JOB BAPTIST PRIMARY CARE-JULINGTON CREEK
LOCATION
CUSTOMER
DRWG. COVERS ISO VIEW

JOB NO. 21-035
DRWG. NO. A-ISO

EAGLE CREEK - LOT 2
ISOMETRIC VIEW

TYPICAL HSS BEAM TO
HSS COLUMN CONNECCTION DETAIL

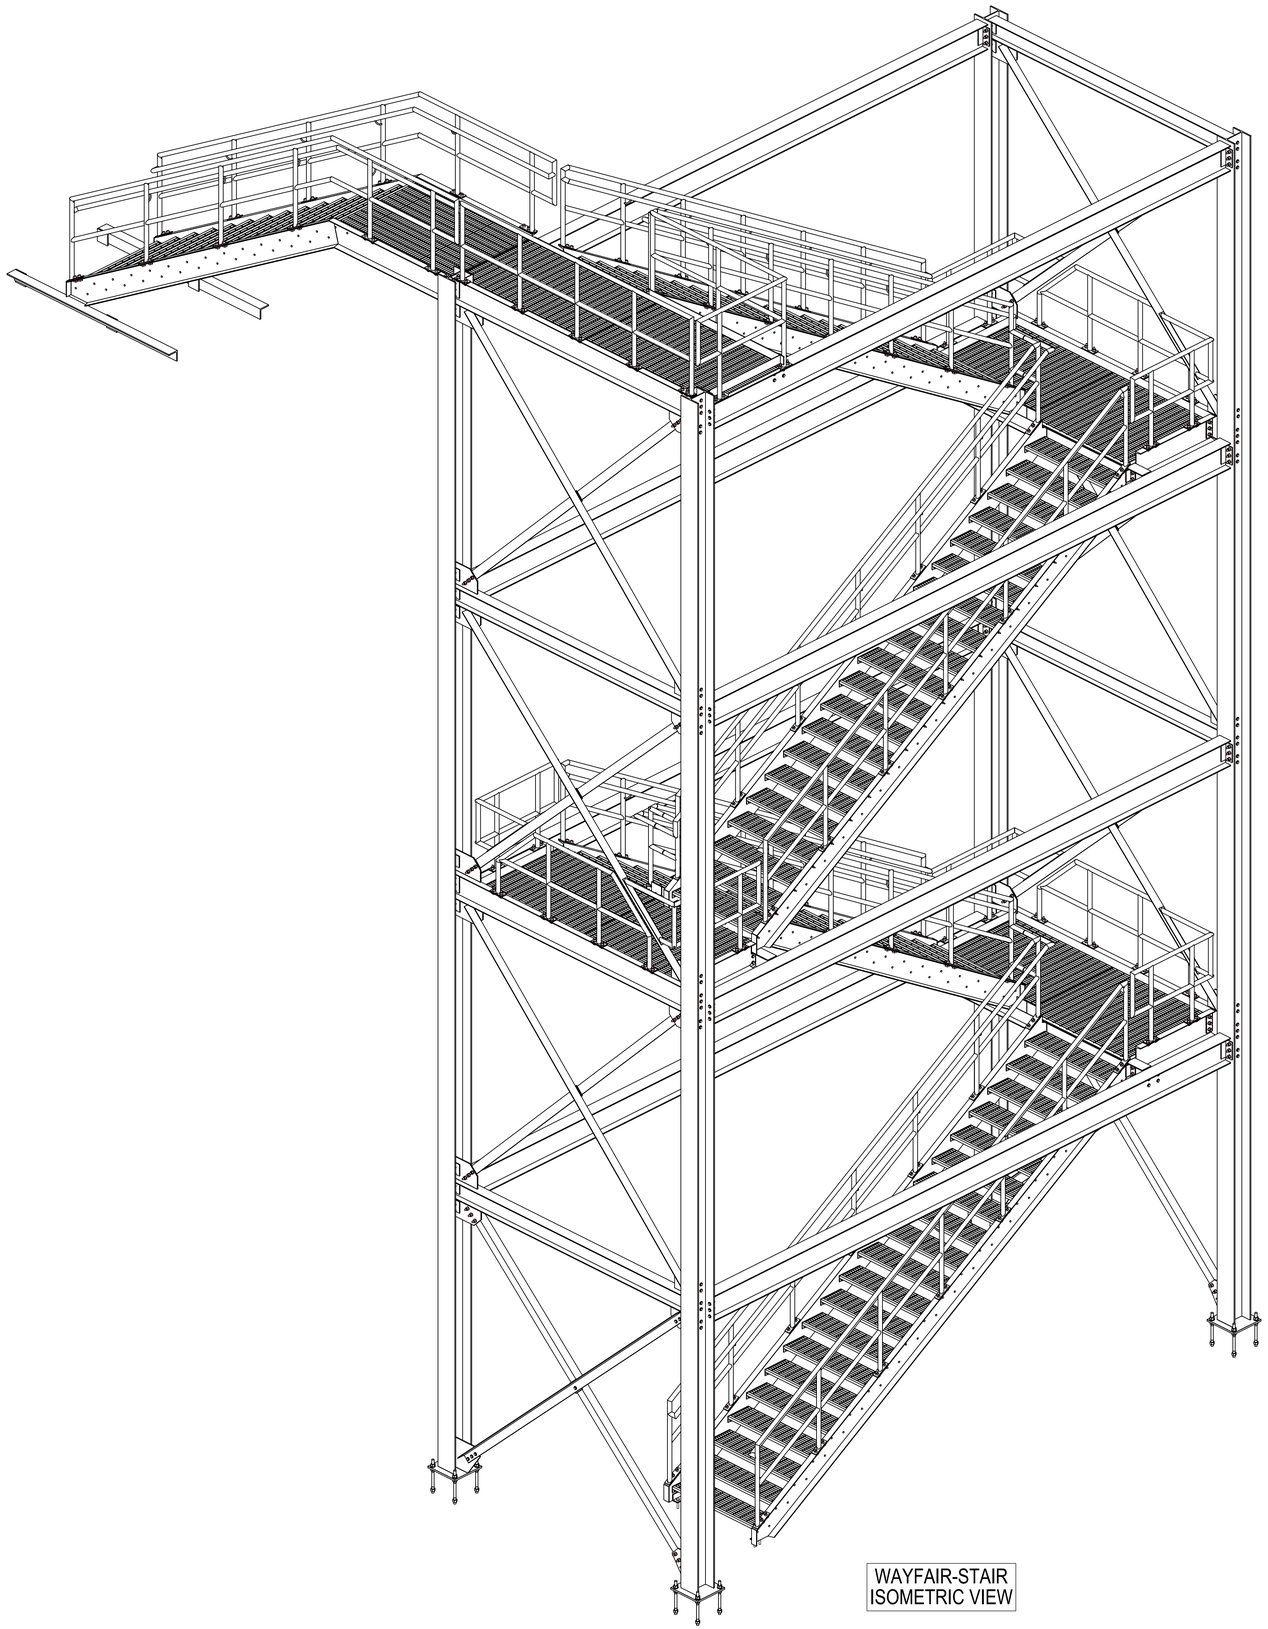
WE HAVE PROVIDED HSS5x5x1/4 OUTRIGGER. APPROVER PLEASE VERIFY THIS IS ACCEPTABLE.

APPROVER PLEASE VERIFY FIELD WELDED CONNECTION OF HSS BEAM TO COLUMN AS DETAILED.

ALL STUBS ARE FROM FACE OF CLIP ANGLES
ALL HOLE SPACING 3" C/C UNLESS NOTED
ALL BLOCK SIZES FROM FACE OF CLIP ANGLES
ALL REAR ENTRANT CUTS HAVE A MINIMUM OF ½" RADIUS CUTS.

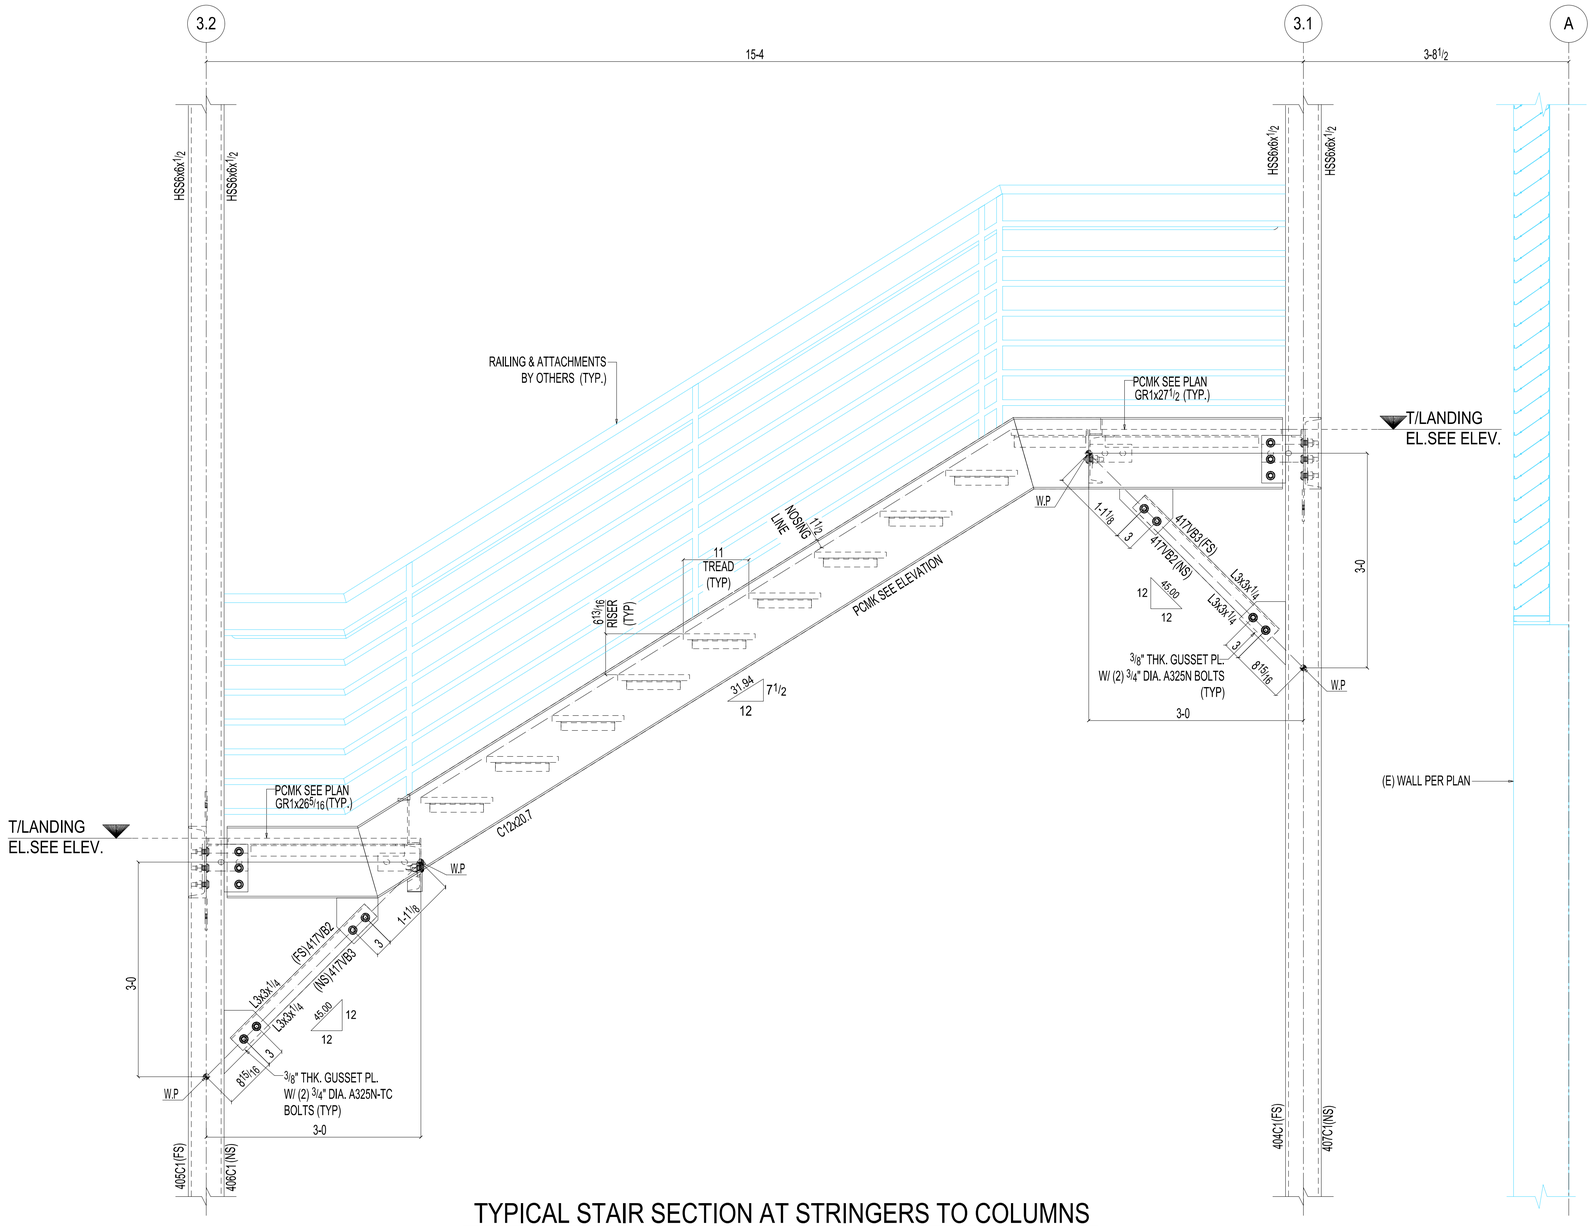
2. WE HAVE PROVIDED AN HSS 2 1/2 X 2 1/2 X 1/4 OUTRIGGER AT 5'-0" O.C. AS NO JOIST IS INDICATED ON THE PLAN. PLEASE CONFIRM IF THE HSS 2 1/2 X 2 1/2 X 1/4 OUTRIGGER IS ACCEPTABLE, OR IF WE NEED TO PROVIDE A 2.5K1 JOIST AS SPECIFIED IN SECTION 2 /3-S5.20.
